Church Hill: The Importance of Thinking in Three Dimensions

A critique of the proposed parking facility at 19-21 Main Street

Eric Lund, 31 Faculty Road, March 2022

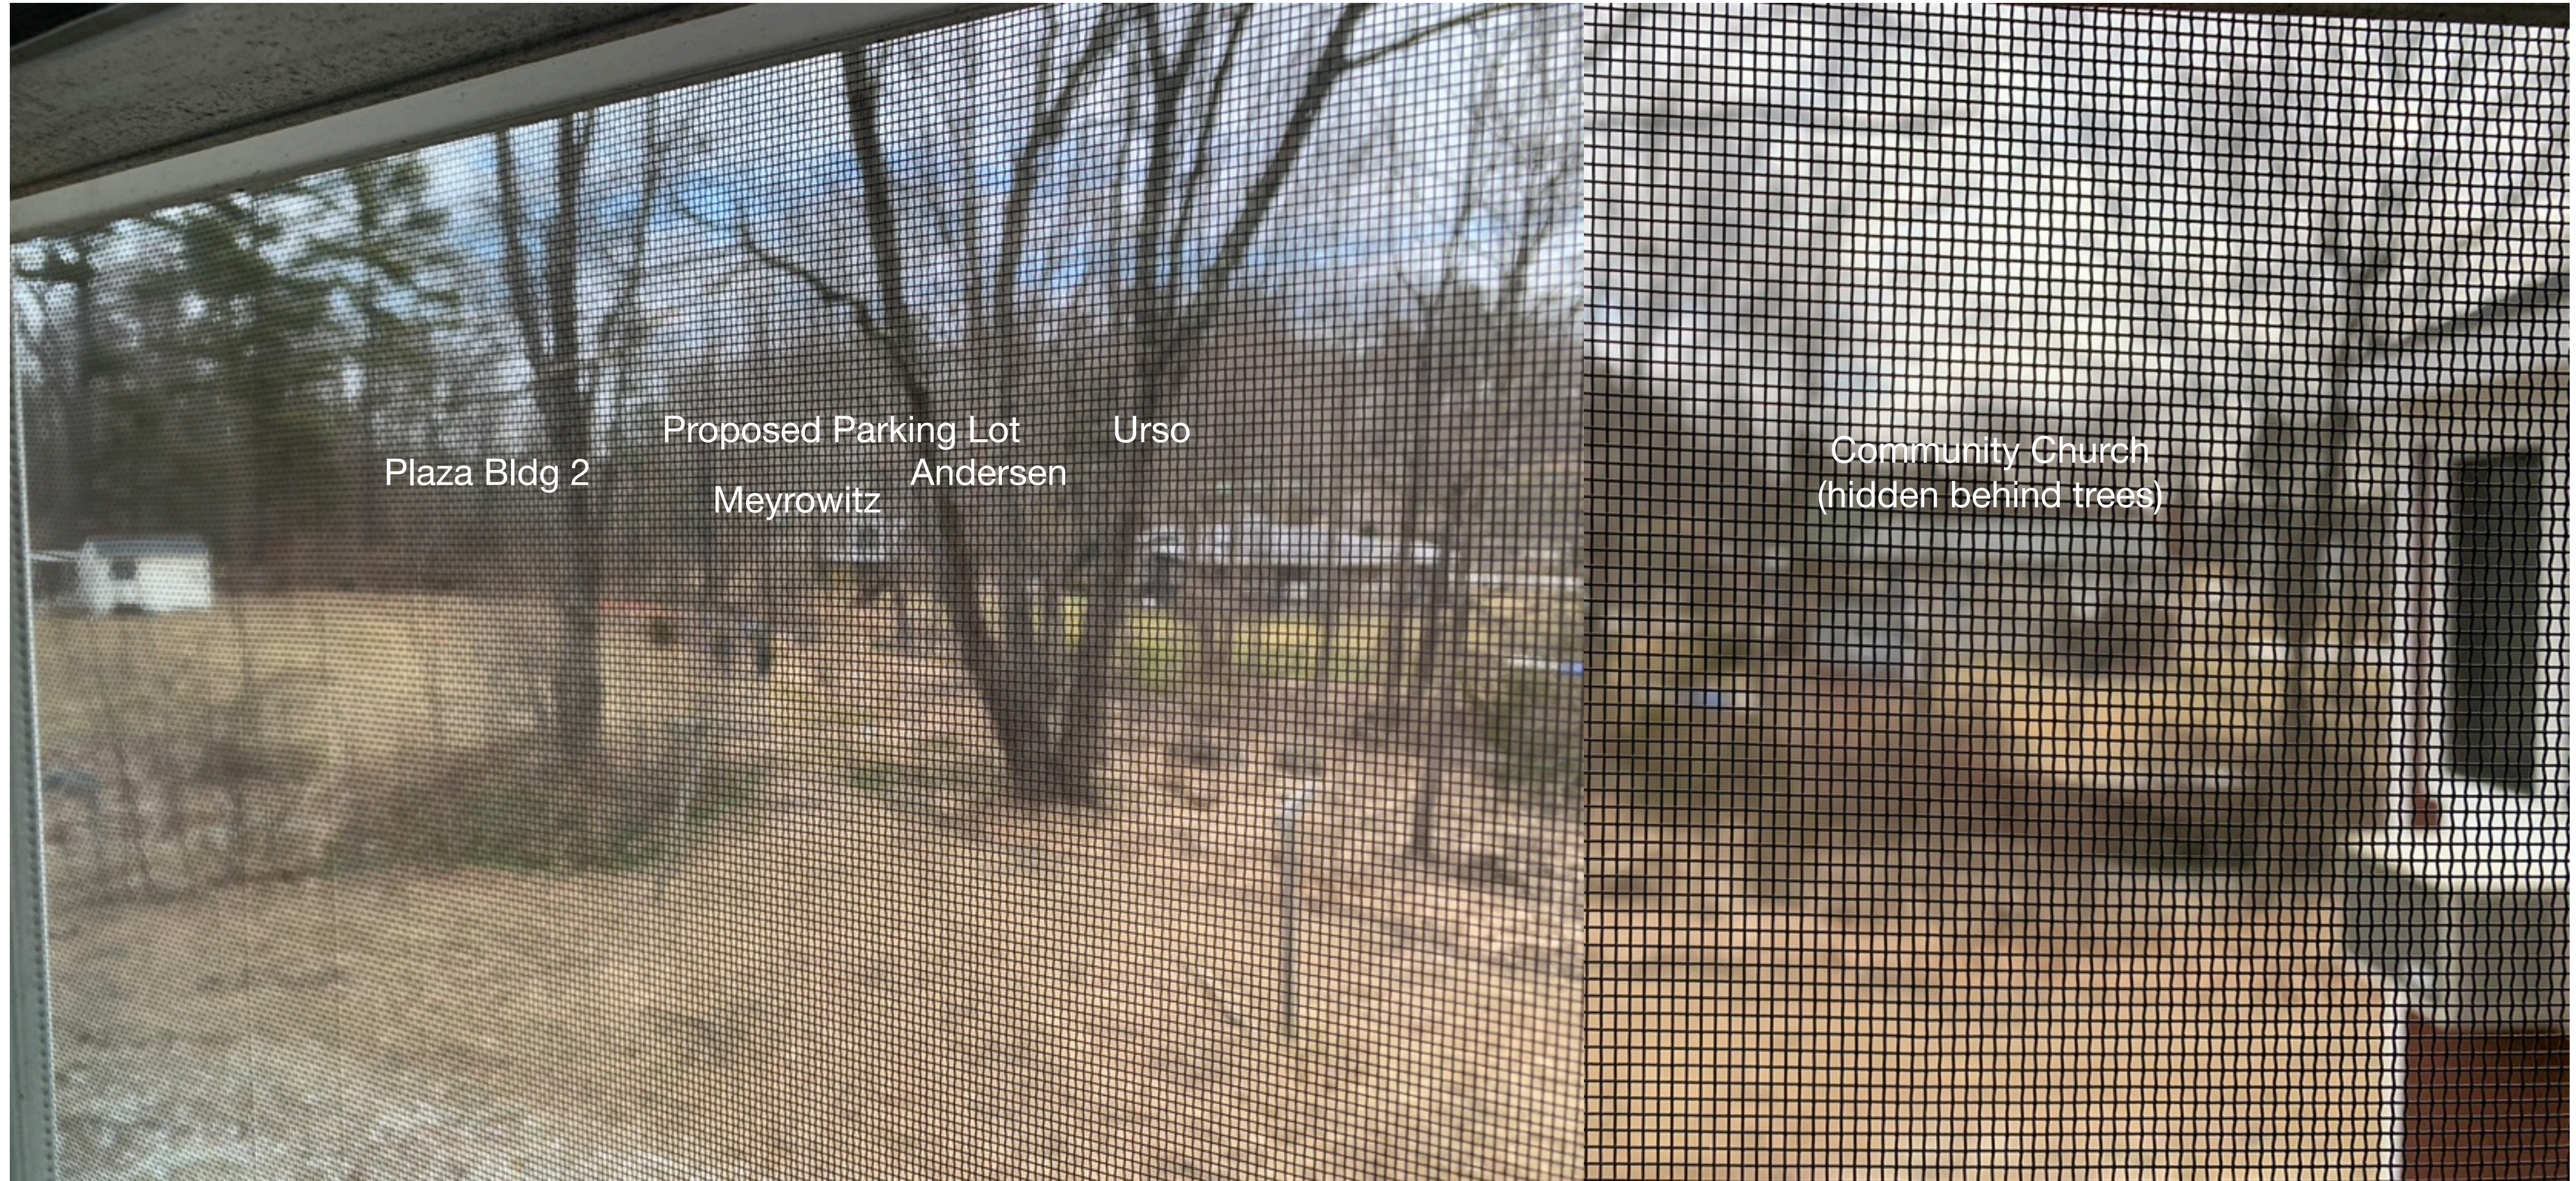
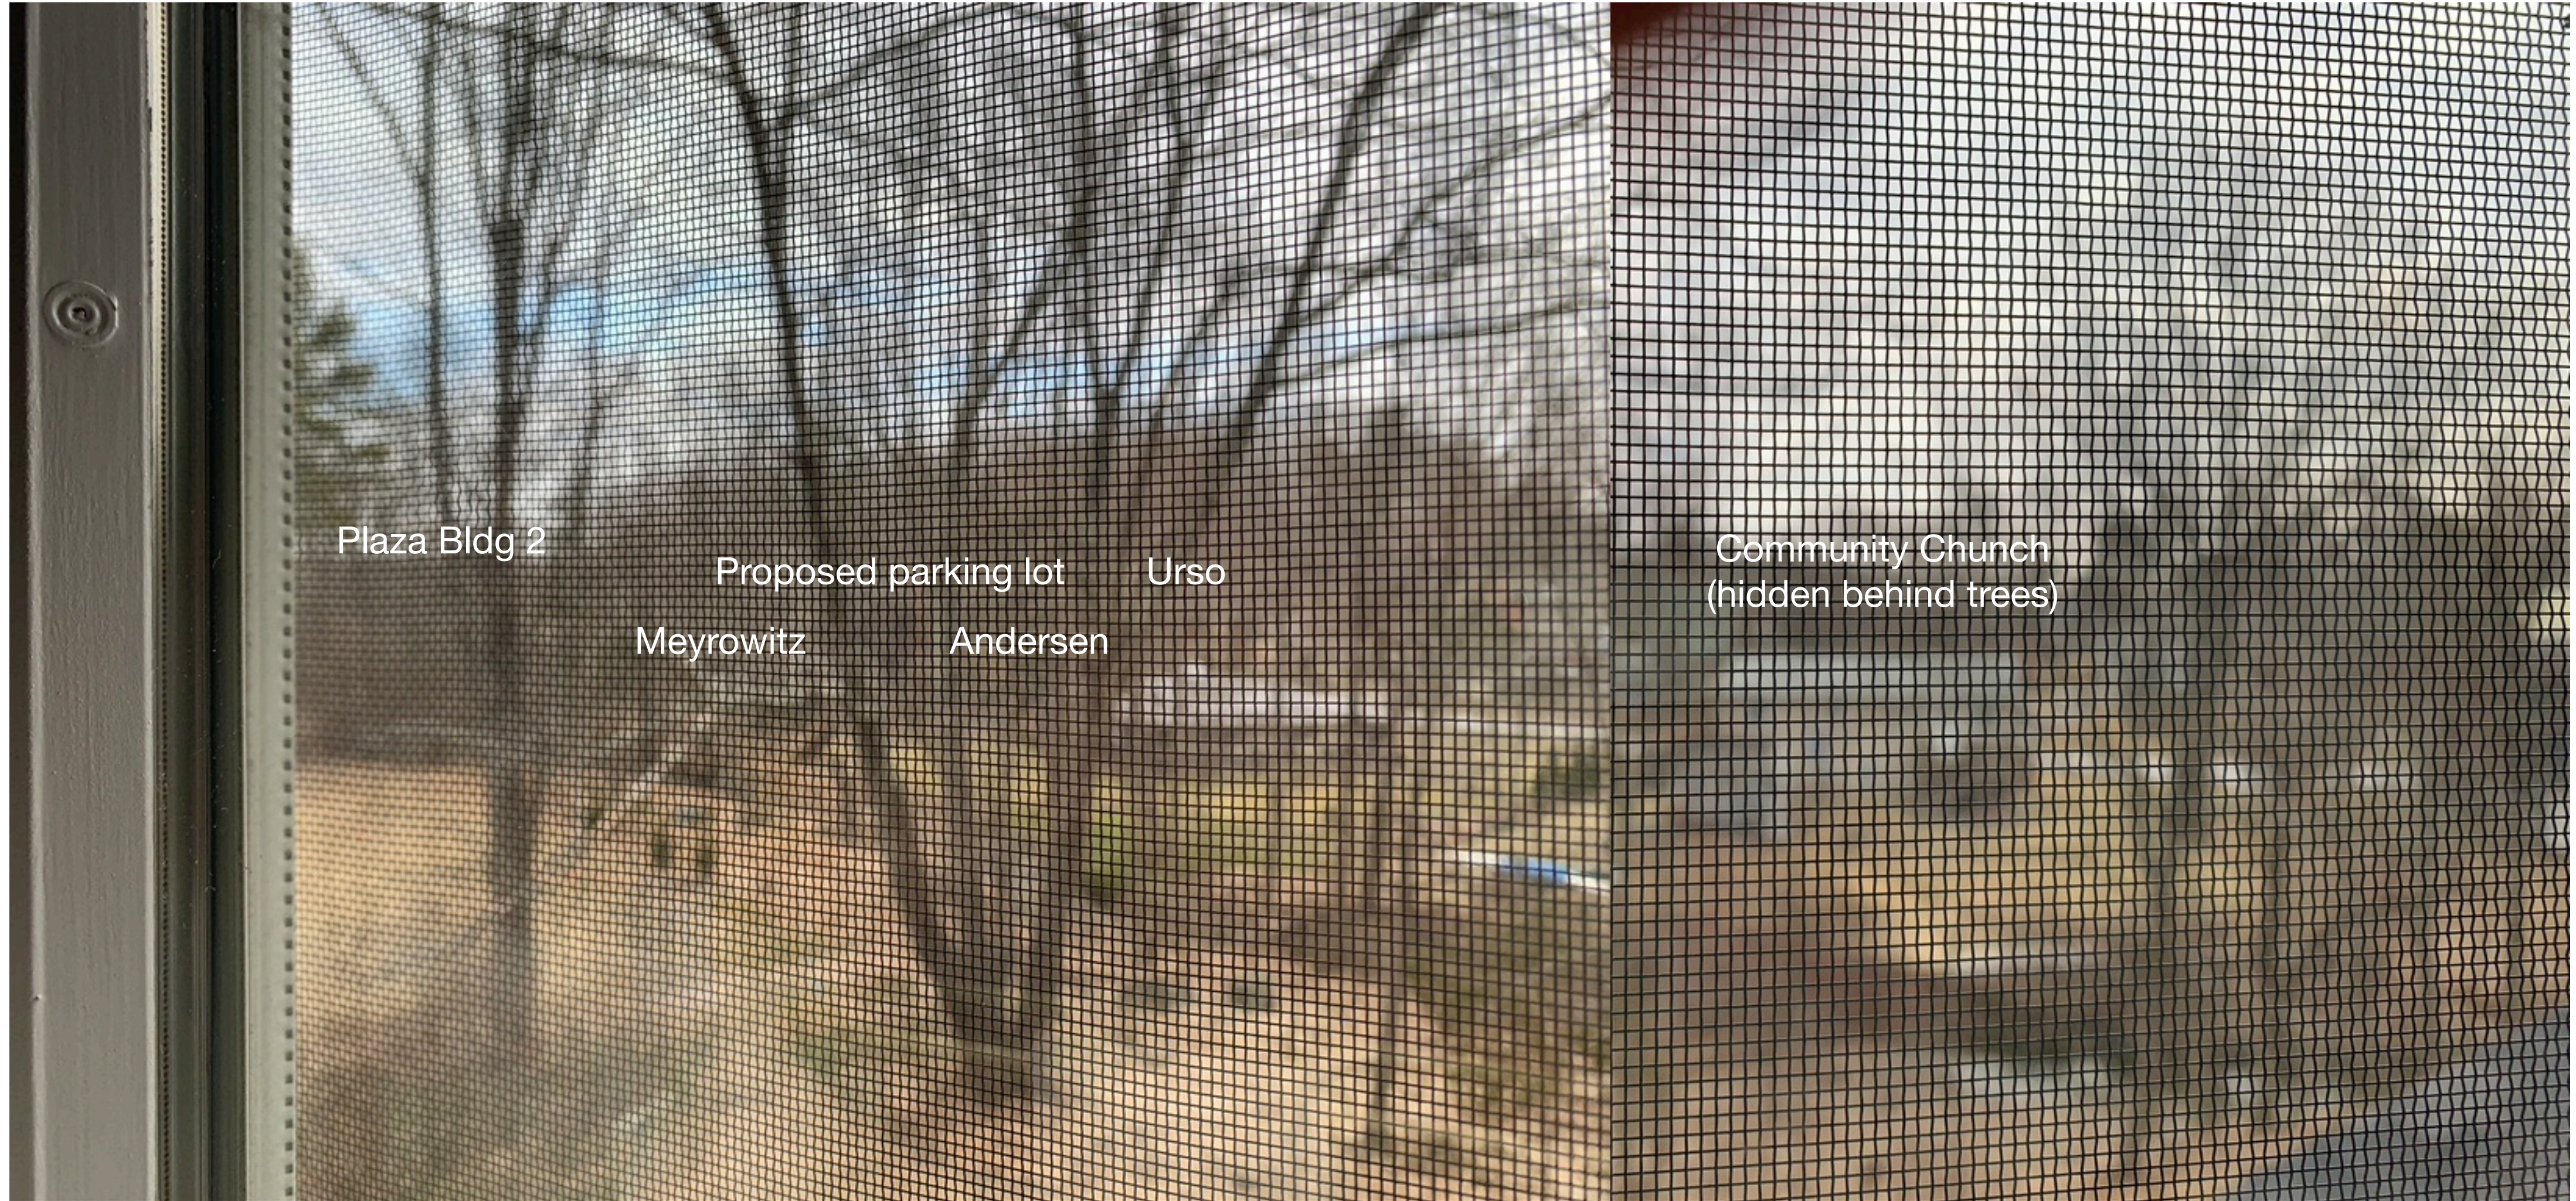
**Summary: Higher elevation,
whether within a house or of the
constructed lot, implies a greater
ability to see and be seen.**

Cone of illumination

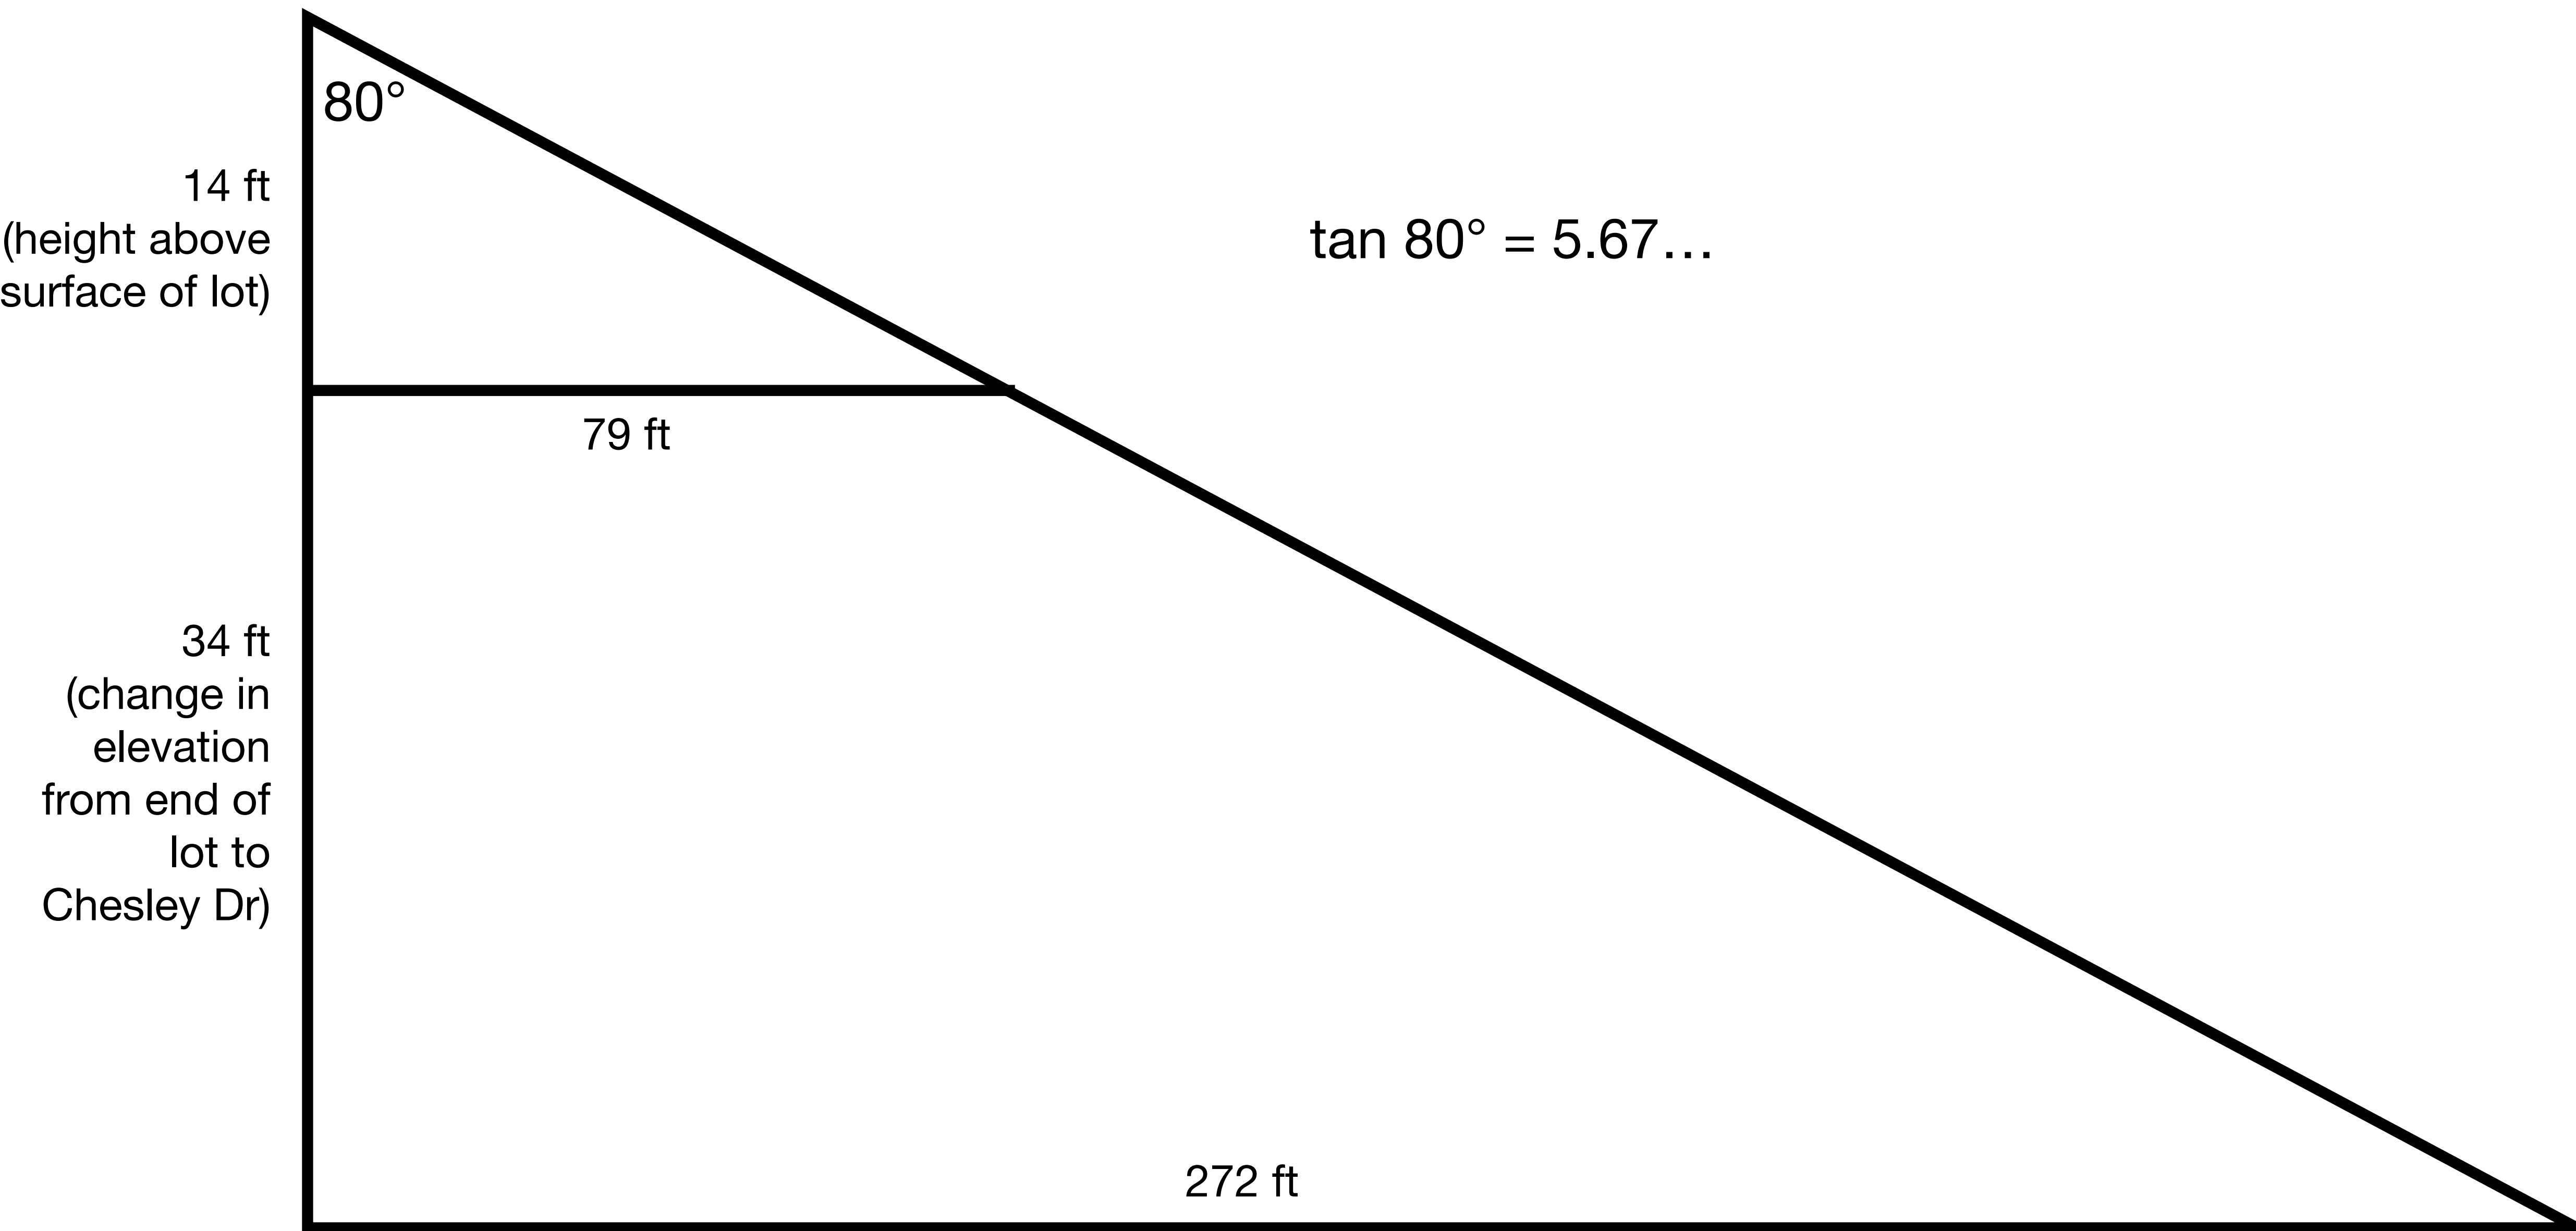
Cone of illumination. A regular conical shaped volume situated directly below, and centered upon, a light fixture. The sides of the cone radiate out from the fixture at an angle of *80 degrees from the vertical*. For wall-mounted fixtures, the cone of illumination is a half cone.

$$\tan 80^\circ = 5.67\dots$$

- Cone of illumination from light fixtures placed around periphery of proposed parking lot includes Urso house and parts of Chesley Drive
- Existing vegetation partially shields these neighbors from impacts of Mill Road Plaza and Community Church lots
- Proposed lot is much closer to neighbors, and many trees that would otherwise shield the light will be removed
- Therefore, absent substantial mitigation, the proposed lot is likely to have lighting impacts for Ursos and Chesley Drive beyond existing nearby uses
